BLDG III - SECOND FLOOR PLAN

CLASS II MODIFICATION 2019 8.2.2019
• REVISE DETAIL AT ARCADE
• ADD TRELLIS BETWEEN III & VI-S

CLASS II MODIFICATION 8.2.2019
• ADD TRELLIS BETWEEN III & VI-S

BLDG VI ELEVATIONS

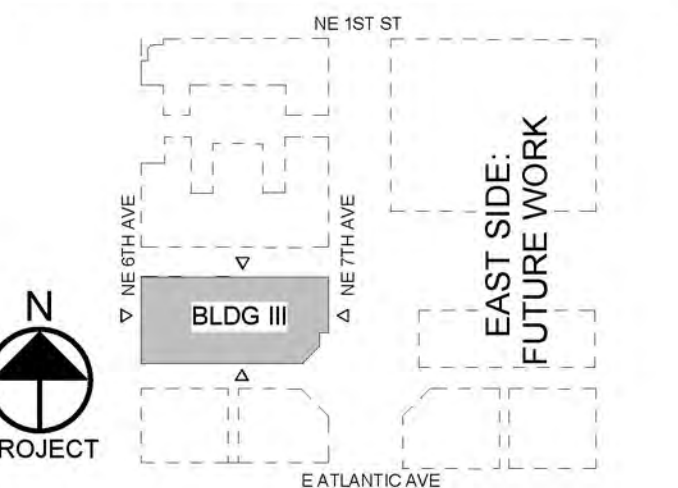
REVISED ARCADE

- ADD TRELLIS BETWEEN III & VI-S

BLDG III - NORTH ELEVATION

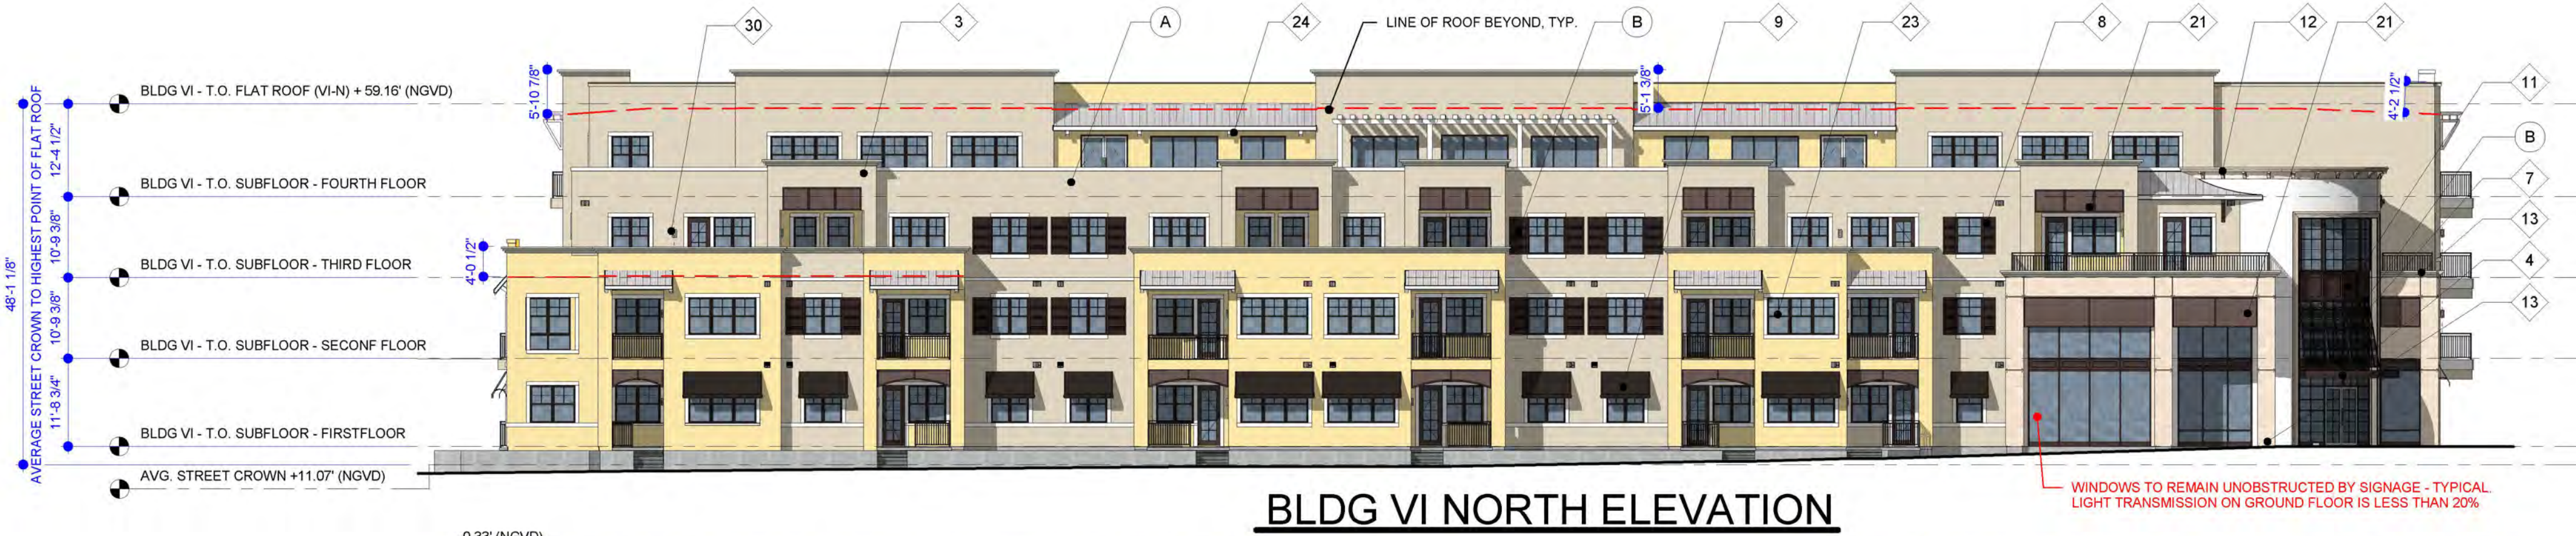
RESPONSE TO 2.12.14 STAFF COMMENTS
• BUILDING III NORTHWEST FOOTPRINT ADJUSTED DUE TO ADDITION OF RAMP AT NE 6TH AVENUE
• WINDOWS OF THE BUSINESSES AND OFFICES REMAIN UNOBSTRUCTED BY SIGNAGE
• LIGHT TRANSMISSION FOR GROUND FLOOR GLASS AREA TO BE NO GREATER THAN 20%
• KNOX BOXES TO BE PROVIDED AT ROLL DOWN GATES
• GREEN WALL IS CONSIDERED A TRELLIS WHICH SHALL BE ALLOWED TO ENCROACH INTO SETBACK ALONG FEDERAL HIGHWAY
• ADDED INGRESS/EGRESS RAMP AT NE 6TH AVE

SETTLEMENT MODIFICATION 4.21.2017
• ADD ARCADE ALONG THE NORTH ELEVATION
• ADJUST POSITION OF LOADING AREA
• ADJUST EAST AND WEST ELEVATIONS DUE TO ADDITION OF ARCADE

ARCHITECTURAL ELEVATION REVISIONS 7.19.2018
GENERALLY REVISE ELEVATIONS TO BE MORE CONSISTENT WITH ANGLO CARIBBEAN, INCLUDING:
• SCULPTED FORMS AT ARCADE AND AT FEATURE ELEMENTS OF THE BUILDING
• RE-SCALE WINDOWS AT CORNERS
• WOOD DETAILING AS ACCENT AT VERTICAL FORMS
• ENTRANCE DETAIL AT BUILDING CAP
• RE-DETAIL ARCADE AND LOW ROOF FORMS

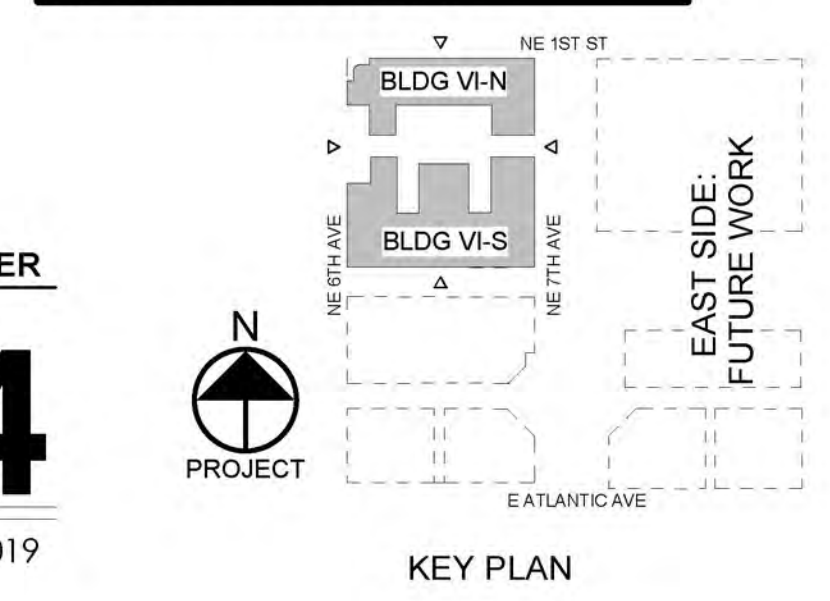
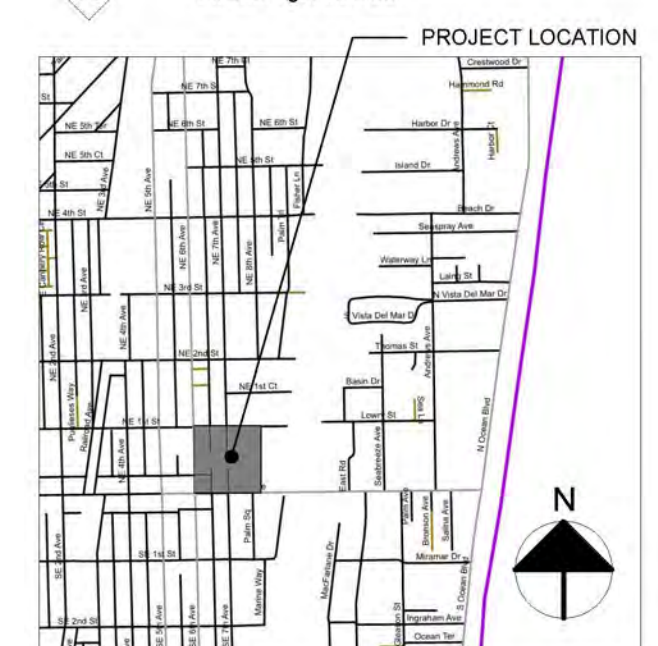
RESPONSE TO 2.12.14 STAFF COMMENTS
• WINDOWS OF THE BUSINESSES AND OFFICES REMAIN UNOBSTRUCTED BY SIGNAGE
• LIGHT TRANSMISSION FOR GROUND FLOOR GLASS AREA TO BE NO GREATER THAN 20%
• KNOX BOXES TO BE PROVIDED AT ROLL DOWN GATES
• ADJUSTED METAL AWNINGS AND ADDED MORE SHUTTERS

SETTLEMENT MODIFICATION 4.21.2017
• RELOCATED ENTRY TO PARKING GARAGE
• ADJUST EAST AND SOUTH DUE TO PARKING GARAGE ENTRY RELOCATION

ARCHITECTURAL ELEVATION REVISIONS 7.19.2018
GENERALLY REVISE ELEVATIONS TO BE MORE CONSISTENT WITH MASONRY MODERN, INCLUDING:
• STRENGTHENING PEDESTRIAN SCALE OF ENTRY TO LEASING (NORTH-WEST CORNER)
• ENHANCED HORIZONTAL DETAILING AT BASE - ADDED ROOF FORMS, CONSOLIDATED COLOR, MINIMIZED TALL SLENDER VERTICAL FORMS
• ENHANCE DETAILING AT BUILDING CORNERS
• ENHANCE DETAILING AT BUILDING CORNERS

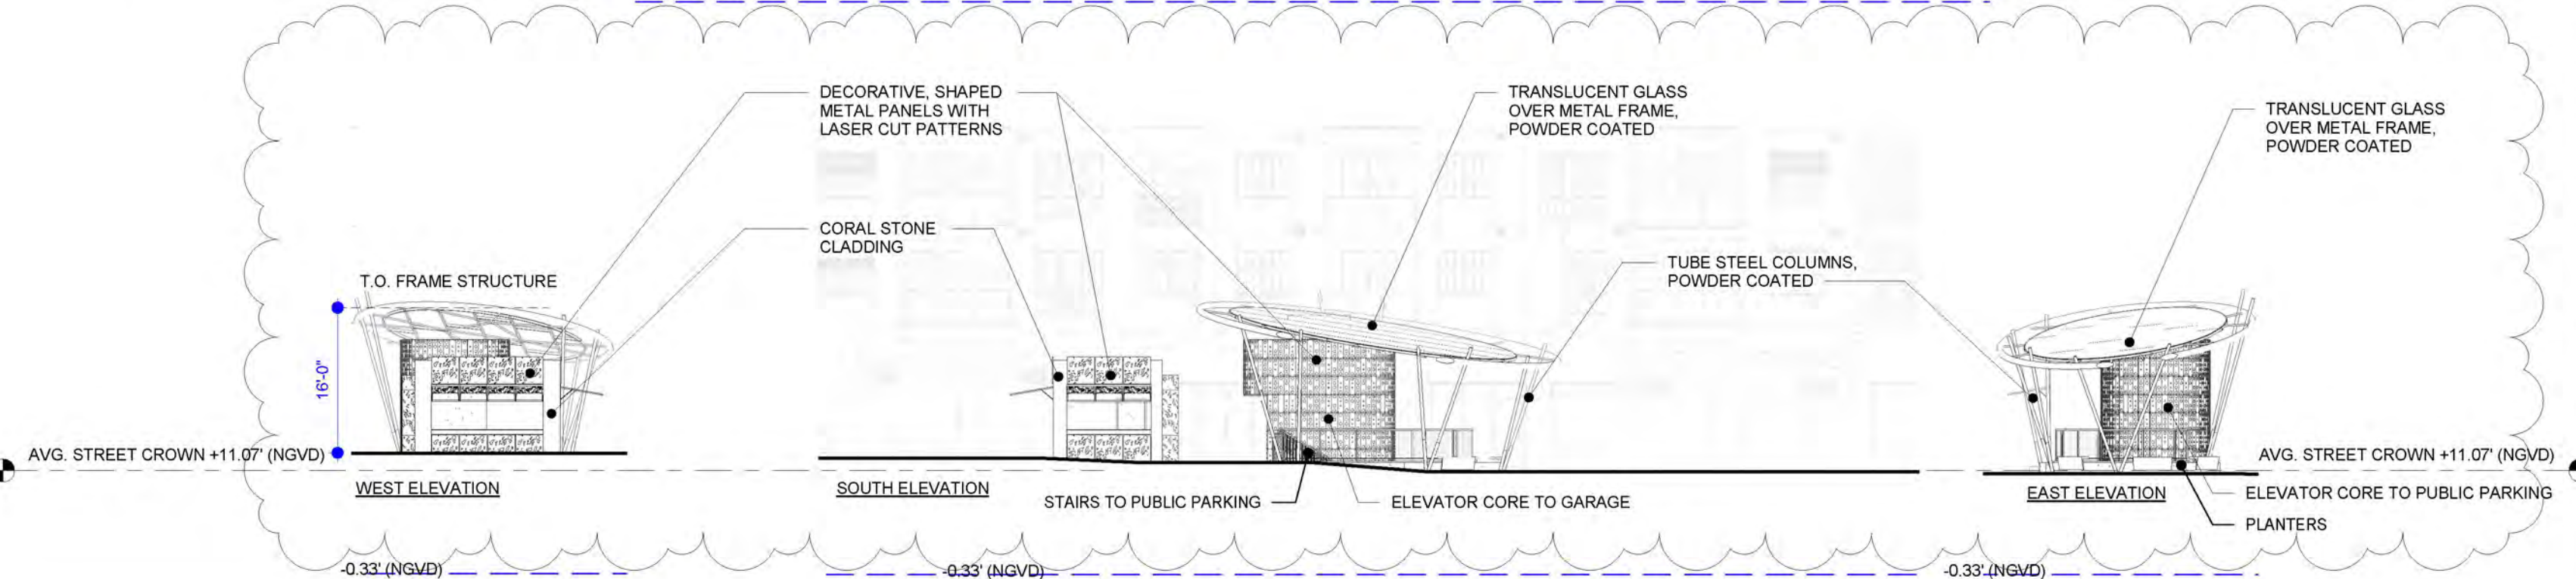
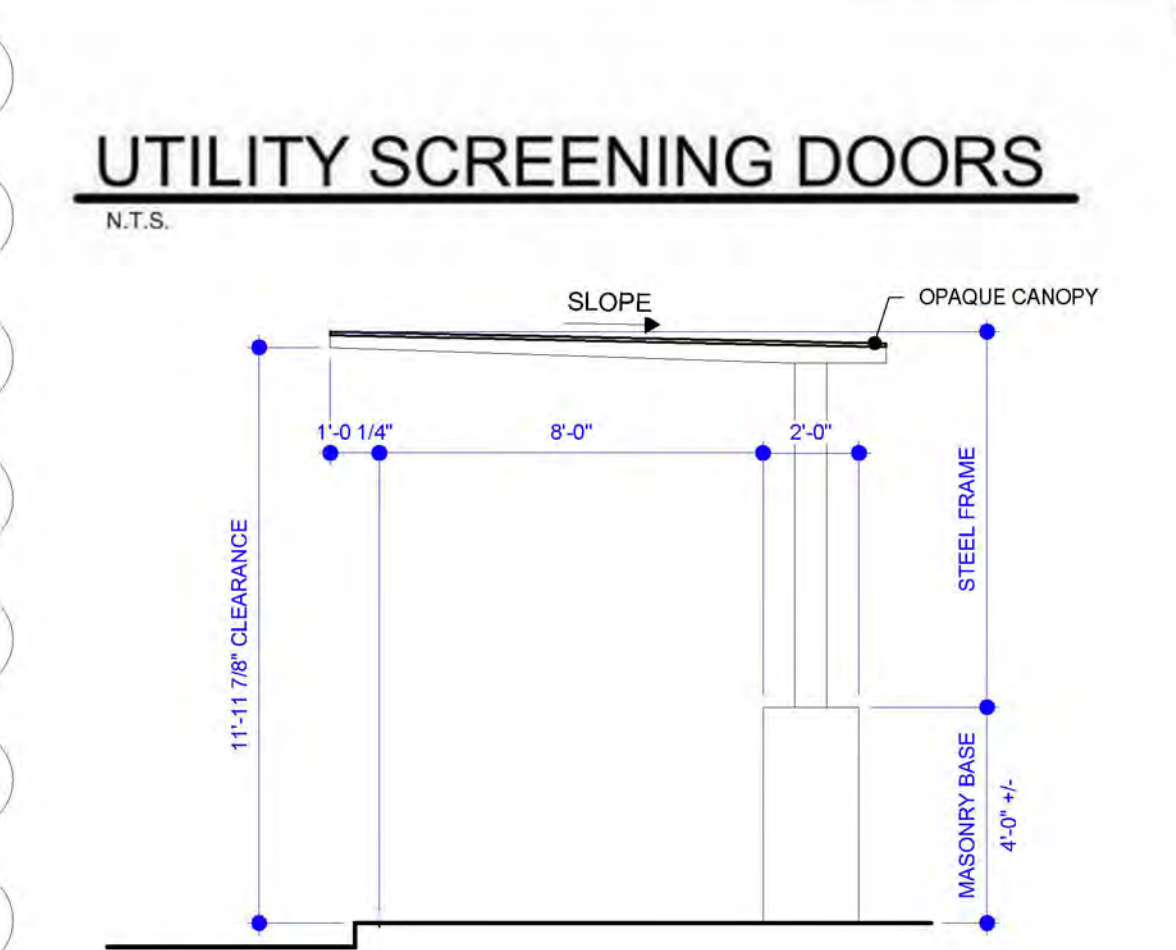
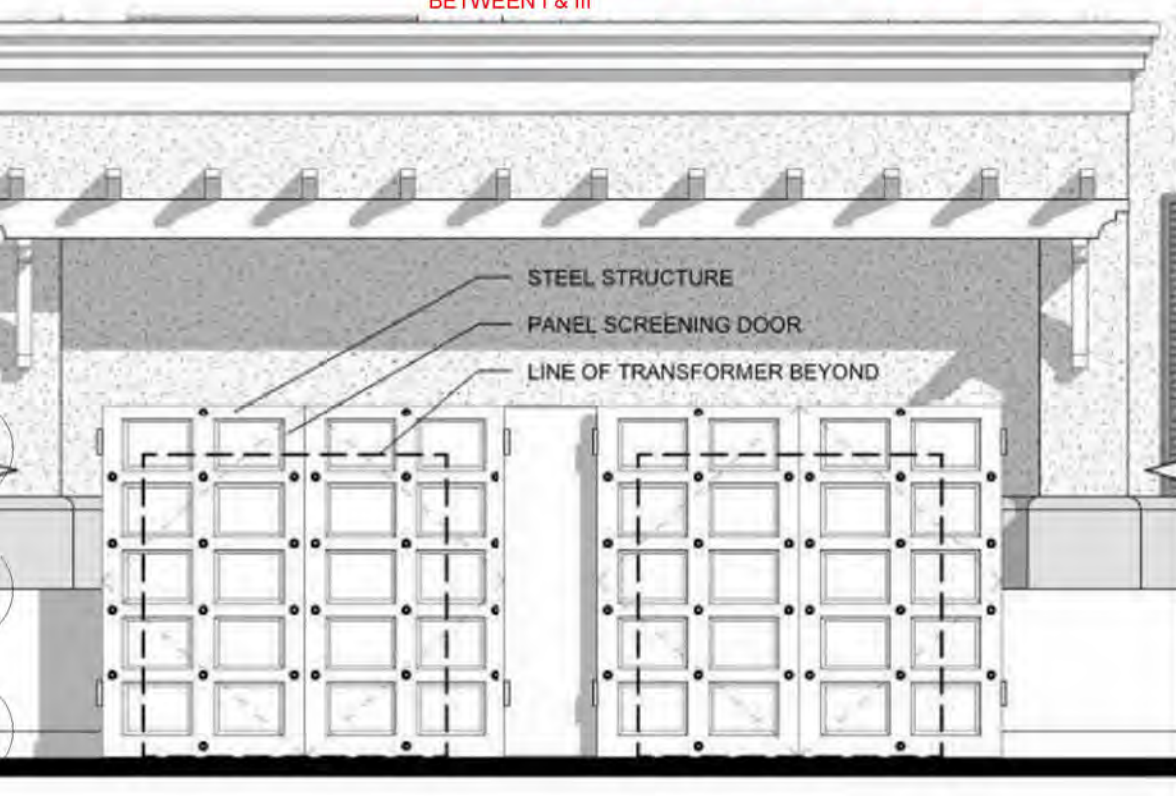
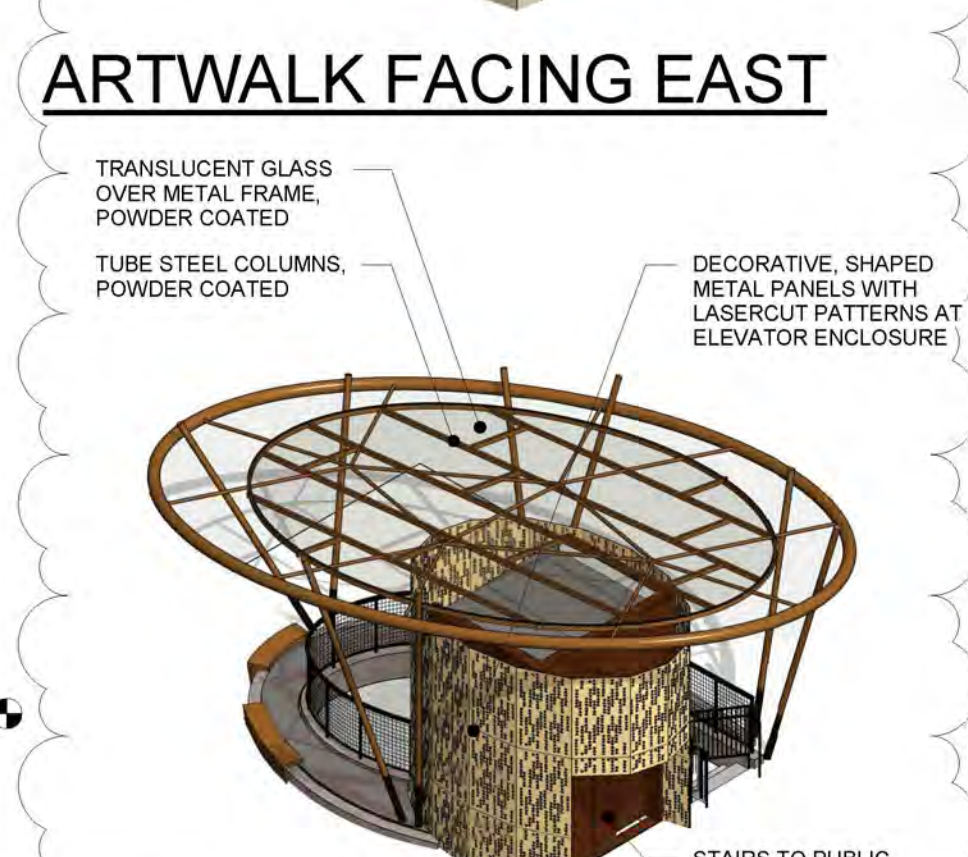
RESPONSE TO 2.12.14 STAFF COMMENTS

- LIGHT TRANSMISSION FOR GROUND FLOOR GLASS AREA TO BE NO GREATER THAN 20%
- PROVIDED ELEVATIONS OF THE SCREENING DOORS AT TRANSFORMER ENCLOSURES

ARCHITECTURAL ELEVATION REVISIONS 1.19.2018

GENERALLY REVISE ELEVATIONS TO BE MORE CONSISTENT WITH MASONRY MODERN, INCLUDING:

- STRENGTHENING PEDESTRIAN SCALE OF ENTRY TO LEASING (NORTHWEST CORNER)
- ENHANCED HORIZONTAL DETAILING AT BASE - ADDED ROOF FORMS, CONSOLIDATED COLOR, MINIMIZED TALL SLENDER VERTICAL FORMS
- ENHANCE DETAILING AT BUILDING CAP
- ENHANCE DETAILING AT BUILDING CORNERS

GLASS II MODIFICATION 8.2.2019

- ADD TRELLIS BETWEEN III & VI-S
- REVISE DETAIL AT ELEVATOR/STAIR/BAR FEATURE BETWEEN I & III
